9.2 Water Systems

The information in this section of the reference ABWR DCD, including all subsections, tables, and figures, is incorporated by reference with the following departures and supplements:

Figure 9.2-6b Turbine Building Cooling Water System Diagram

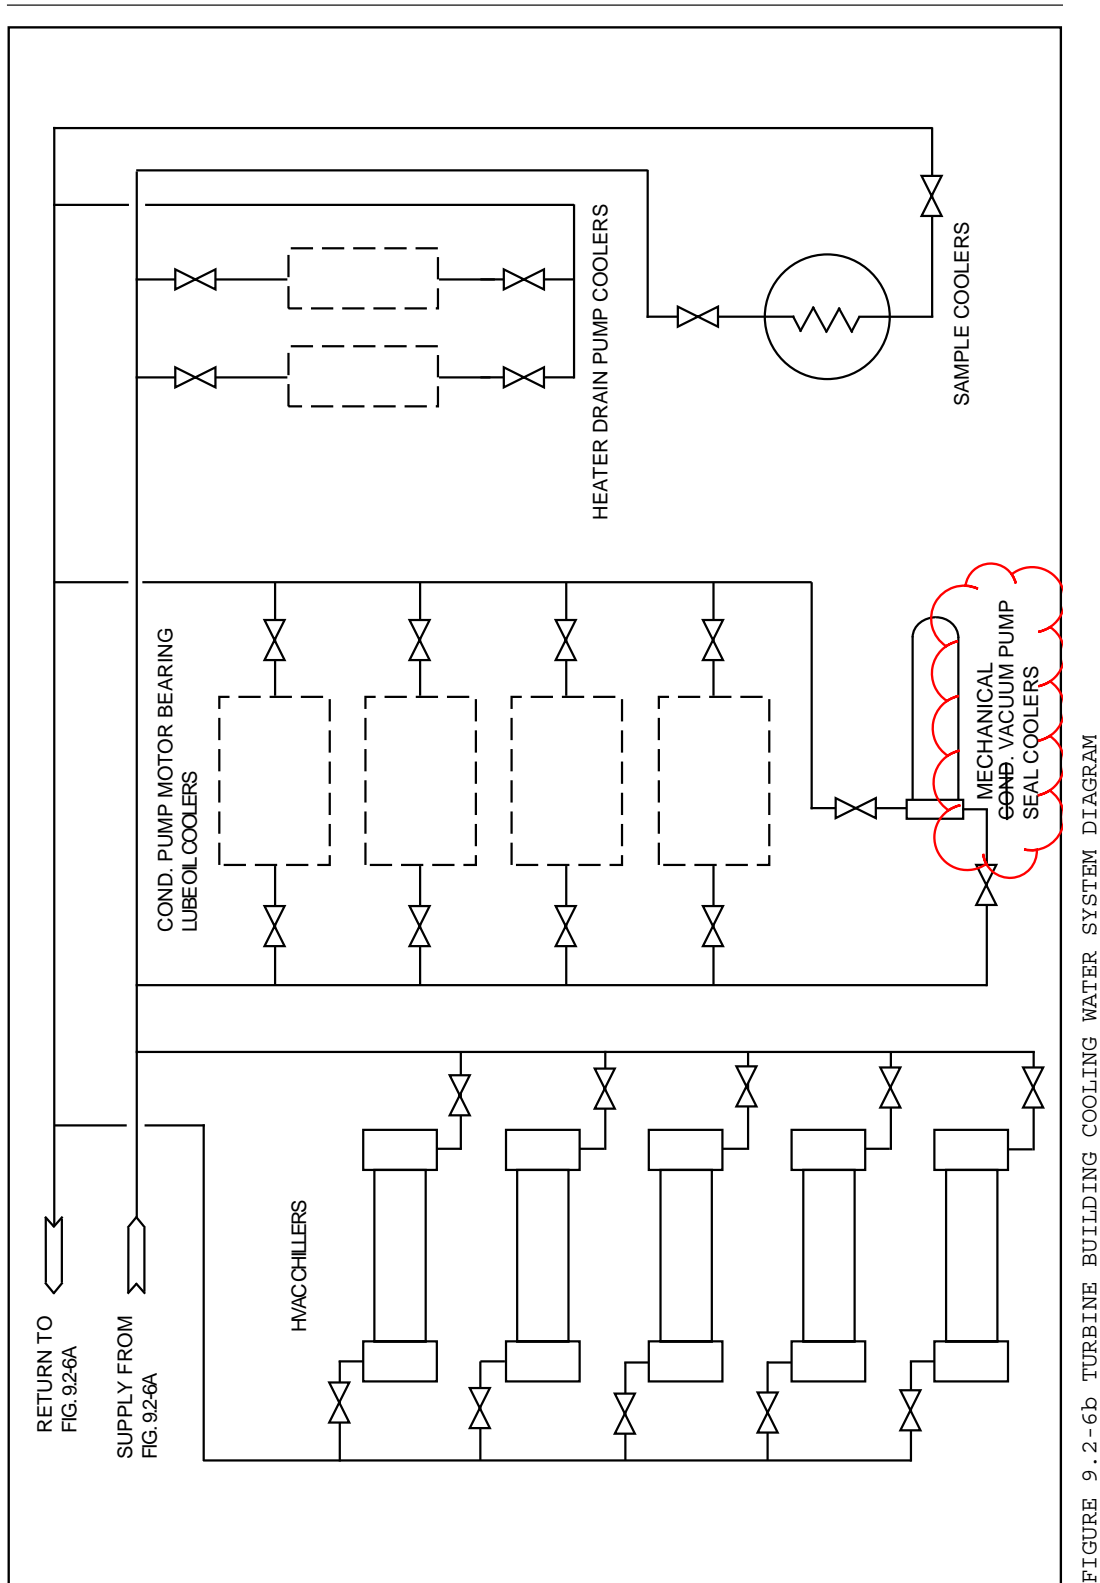
STD DEP Admin (Table 9.2-11, Figure 9.2-6b)

Figure 9.2-8 Turbine Building Service Water System

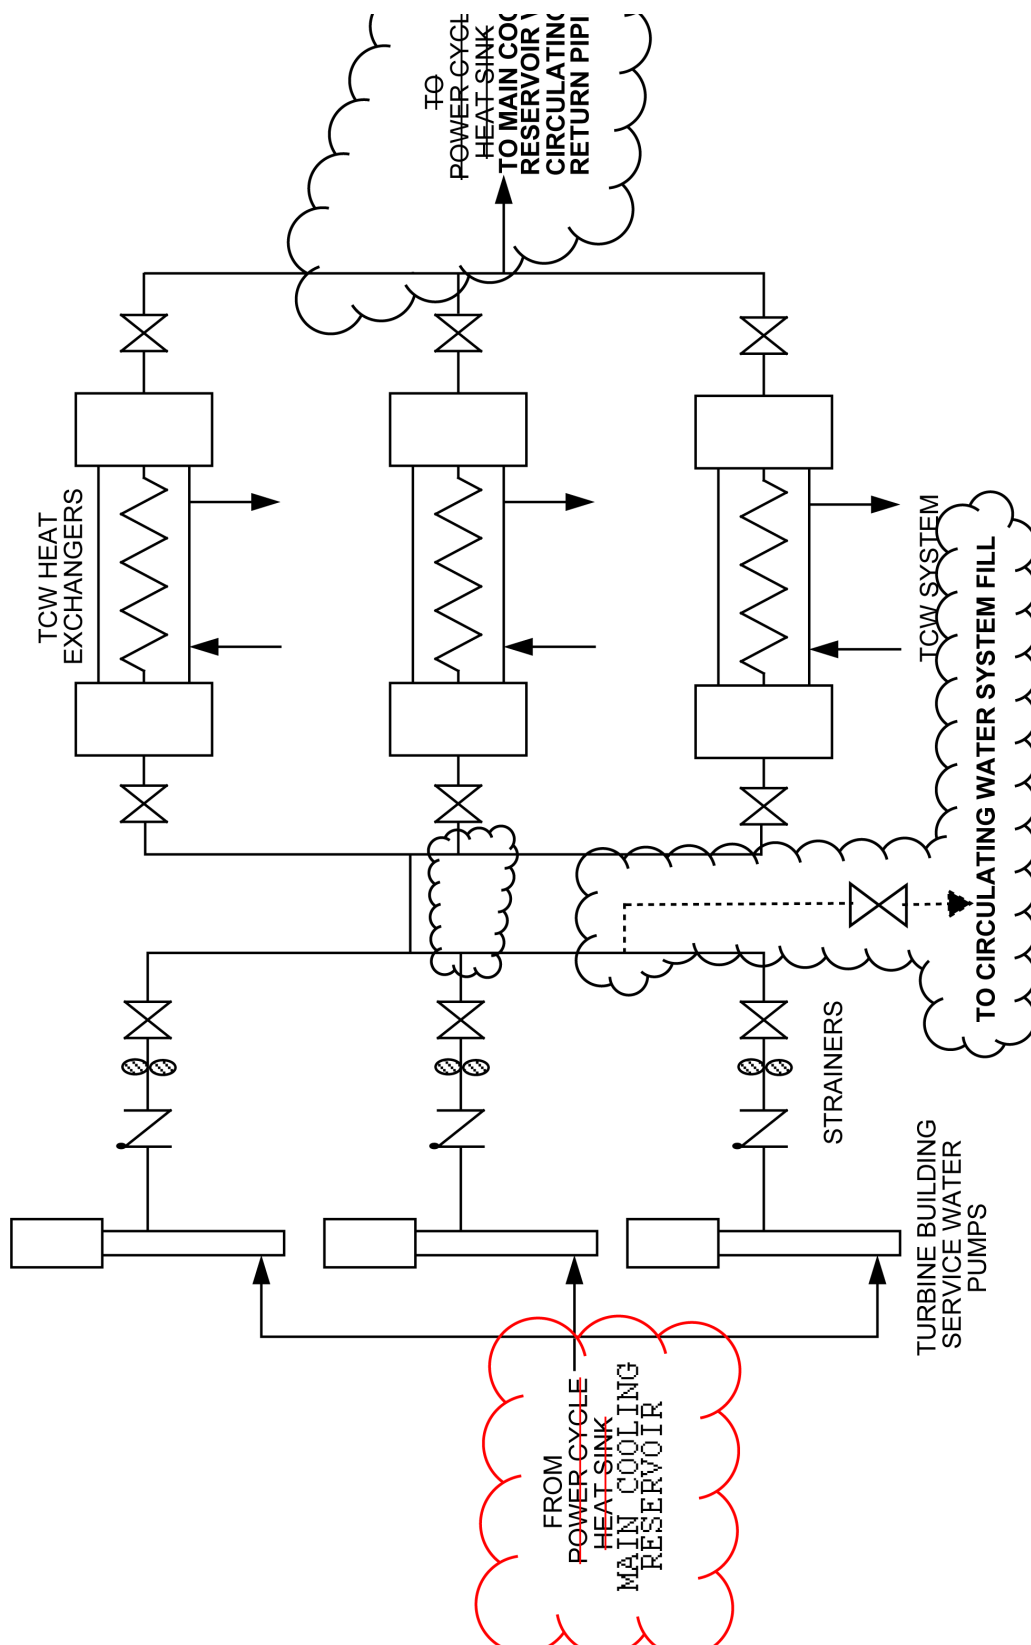
The TSW system, illustrated in Figure 9.2-8 with site-specific design information, consists of three 50% capacity vertical wet pit pumps located in the circulating water intake structure. Two pumps are in operation during normal operation with one pump in standby.

Figure 9.2-9 Potable and Sanitary Water System (Sheet 1 of 2)

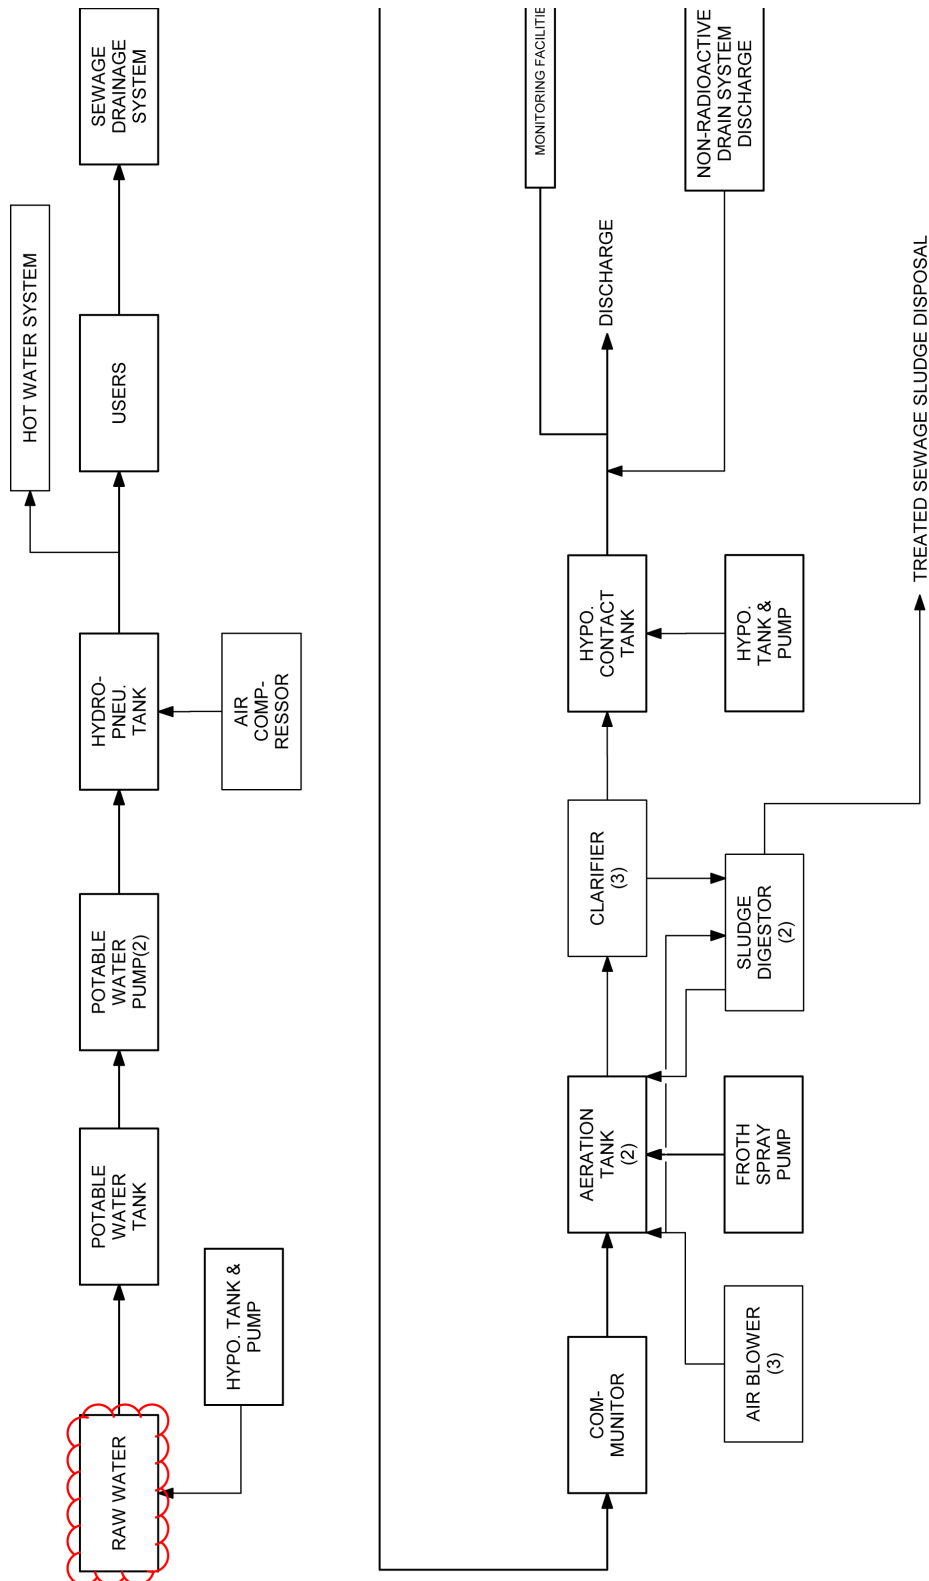
STP DEP 9.2-8 (Table 9.2-14 and Figure 9.2-9 Sheet 1 of 2)

- (1) *The PSW System is designed to provide to all buildings at STP 3 & 4 a minimum of ~~45 m³/h~~ 90 m³/h of potable water intermittently during peak demands.*
- (2) *Potable water will be supplied directly off of the well water system and is ~~filtered~~ and chemically treated to prevent harmful physiological effects on plant personnel.*
- (3) *The PSW System includes a sewage treatment system which treats sanitary waste for all four units at the STP site using the activated sludge biological treatment process. The aeration tanks are capable of receiving waste at a rate between ~~45~~ 220 m³/d and ~~185~~ 480 m³/d.*
- (6) *The emergency eyewash and shower stations require the use of tepid water.*

Figure 9.2-10 Makeup Water Preparation System (Interface Requirements)

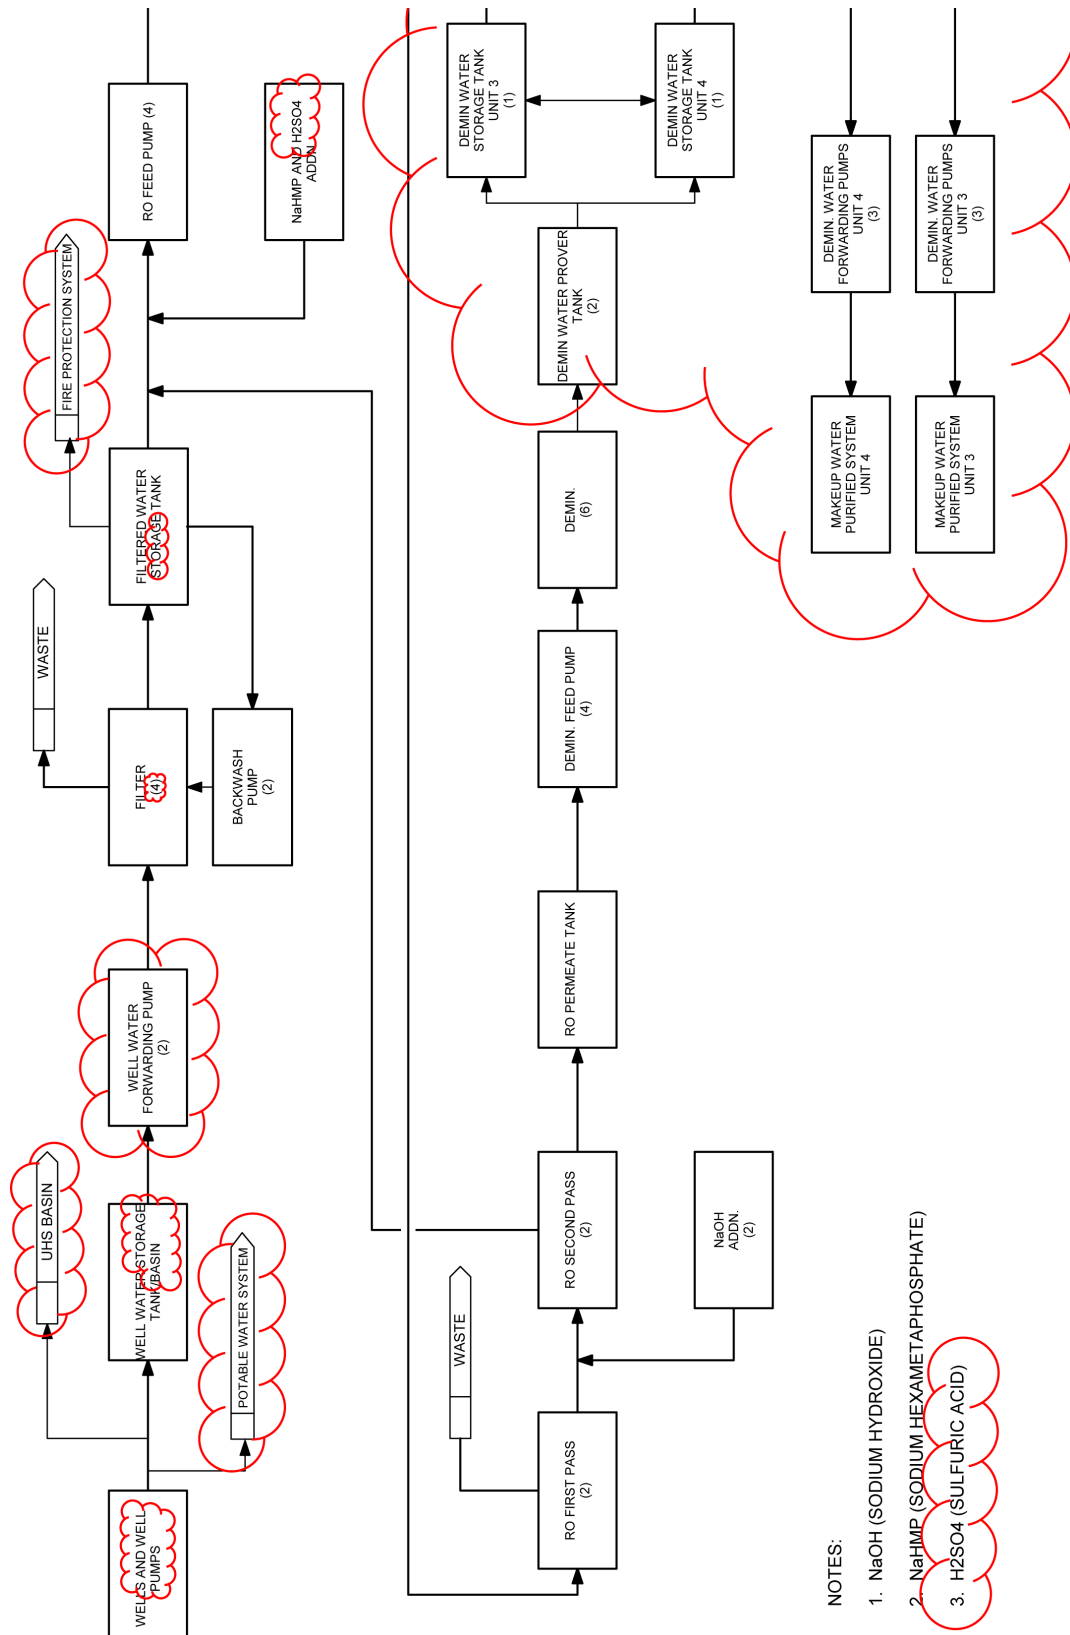
STP DEP 9.2-2 (Table 9.2-15, Figure 9.2-10)

- (1) *The MWP System consists of reverse osmosis (RO) modules arranged in two divisions capable of producing ~~at least 45 m³/h~~ 90 m³/h each (In two-pass series configuration, the divisions are rated at 45 m³/h each to satisfy the demands for each unit); one RO permeate tank and two divisions of demineralizers capable of producing 90 m³/h of demineralized water each.*

- (2) *Storage of demineralized water shall be at least ~~760~~ 5320 m³.*
- (4) *Demineralized water shall be provided by demineralized water forwarding pumps and associated piping at a minimum flow rate of approximately 135 m³/h per unit at a temperature between 10° to 38°C for short durations.*
